Modification Bulletin

Model: Iris/Lilac/Cattleya Platen Cover Dat			Date	e: 09-Mar-0	1	No.: MA749001		
Modified Article: Platen Cover Hinge				Prepared by: M. Tsuyuki				
From: Technical Services Dept., GTS Division								
Reason for	Parts catalog correction Vendor ch		or ch	ange	🗌 To n	To meet standards		
Modification:	odification:		nprove	rove reliability ()		
Part standardization

Model: Iris/Lilac /Cattleya Platen Cover Date			e: 24-Oct-0 [,]	1	No.: MA749002				
Modified Article: Hinge Holder					Prepared by: M. Tsuyuki				
From: Technical Services Dept., GTS Division									
Reason for Parts catalog correction Vendor cl			lor ch	ange	🗌 To n	neet standards			
Modification:		To improve reliability		()				
	Part standardization	⊠ Other

Model: Iris/Lilac/Cattleya Platen Cover Date				e: 24-Oct-0 ⁻	1	No.: MA749003			
Modified Article: Platen Cover Hinge					Prepared by: M. Tsuyuki				
From: Technical Services Dept., GTS Division									
Reason for	Parts catalog correction Vendor of			ange	🗌 To n	neet standards			
Modification: 🗌 To facilitate assembly 🛛 🖾 To impro		improve reliability		()				
	Part standardization	Other

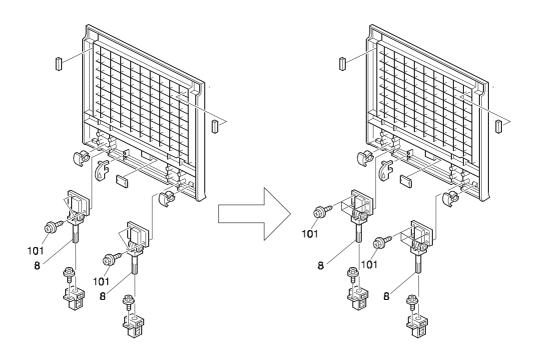
Old part	New part	Description	Q'ty	Int	Page	Index	Note
number	number						
A7491021	A7491121	Platen Cover Hinge	2	X/O	3	8	
04504016B		Tapping Screw – M4x16	4→8	X/O	3	101	
	04504025H	Tapping Screw – M4x25

To prevent the mounting position of the platen cover hinge from being damaged, the platen cover has been modified and the number of screws which mount the hinge on the platen cover changed from two to four.

This modification has been done from June 2000 production.

1. Platen Cover Type 100 (A749)

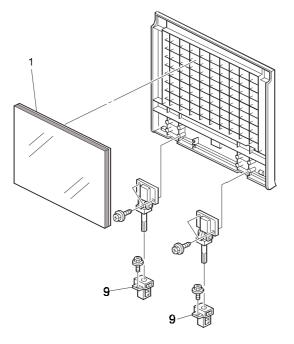
To ensure that the original is flat and secure against the exposure glass, the Platen Cover Cushion has been thickened and the height of the Hinge Holder has been increased.

Old part	New part	Description	Q'ty	Int	Page	Index	Note
number	number						
A7491007	A7491107	Platen Cover Cushion	1	X/X	3	1	*
A7491035	A7491135	Hinge Holder	2	X/X	3	9	*

*Note: The two new parts should be replaced together as a set.
